AGENDA
La Vergne Planning Commission
March 28, 2023 at 6:00 PM

MINUTES OF THE REGULAR MEETING OF THE CITY OF LA VERGNE PLANNING COMMISSION HELD ON FEBRUARY 28, 2023, AT LA VERGNE CITY HALL, LA VERGNE, TENNESSEE.

Sheet 1 of 9

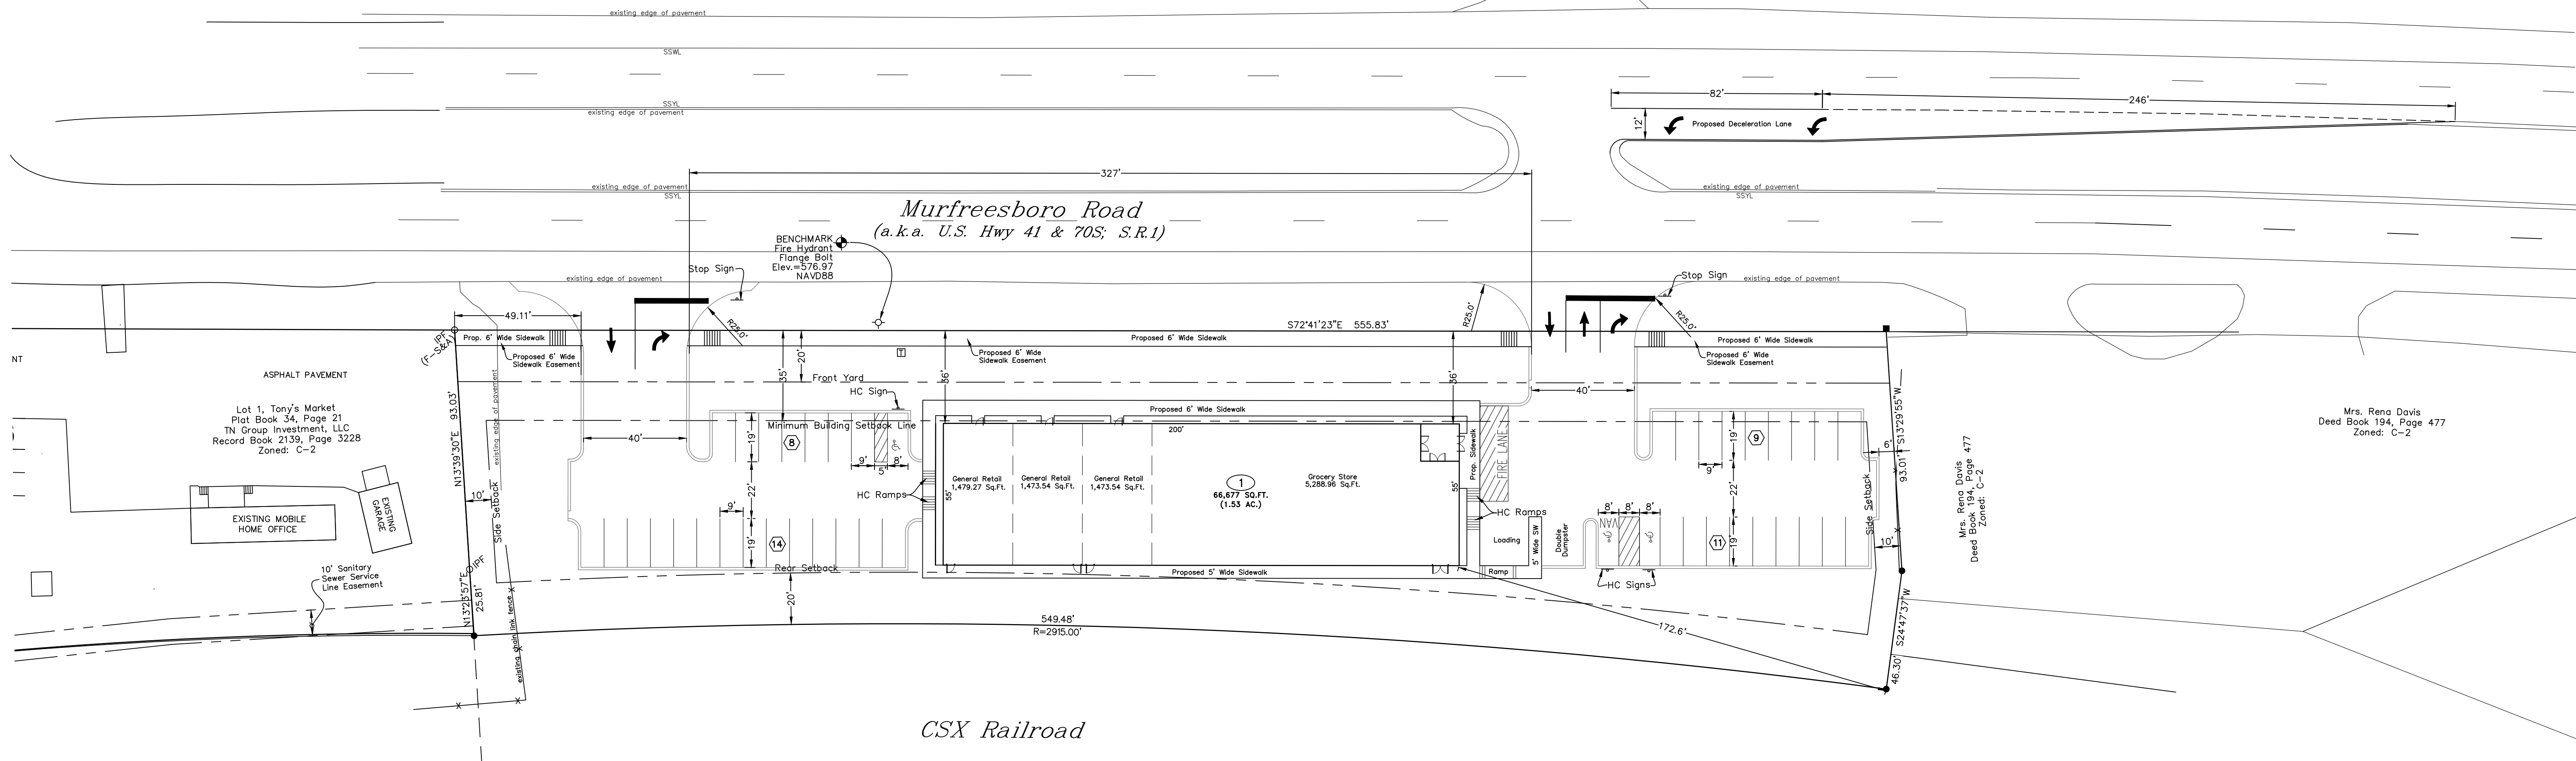
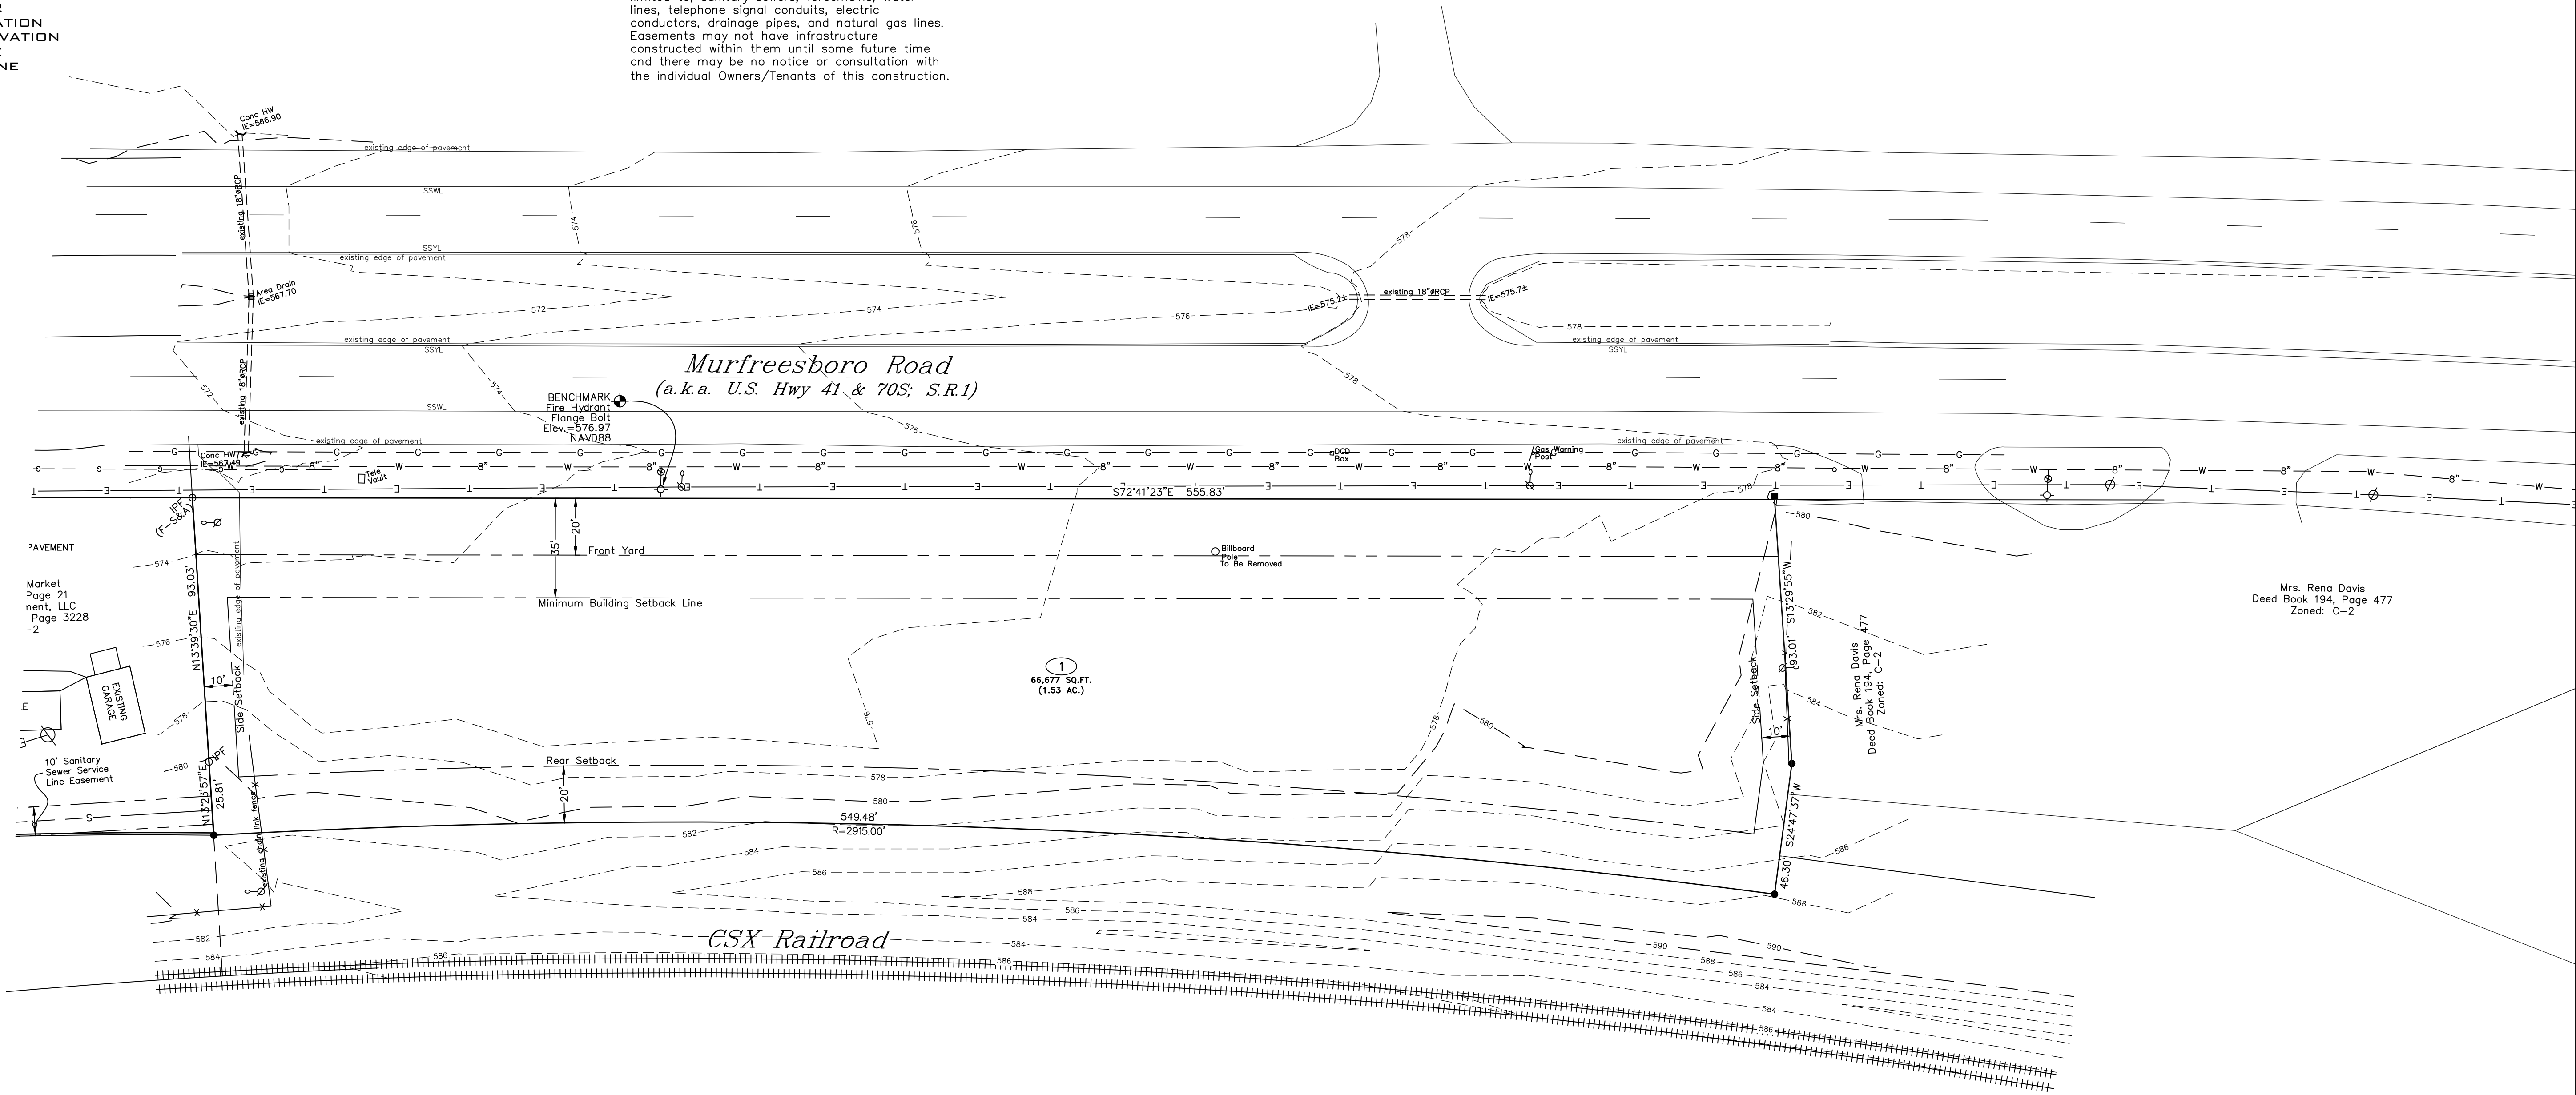
1. (Sheet 1 of 9) The two 60' deceleration lanes have been removed and replaced with a left turn lane from the northbound lane of Murfreesboro Road into the eastern driveway access of the site. Please provide the reasoning for this change.
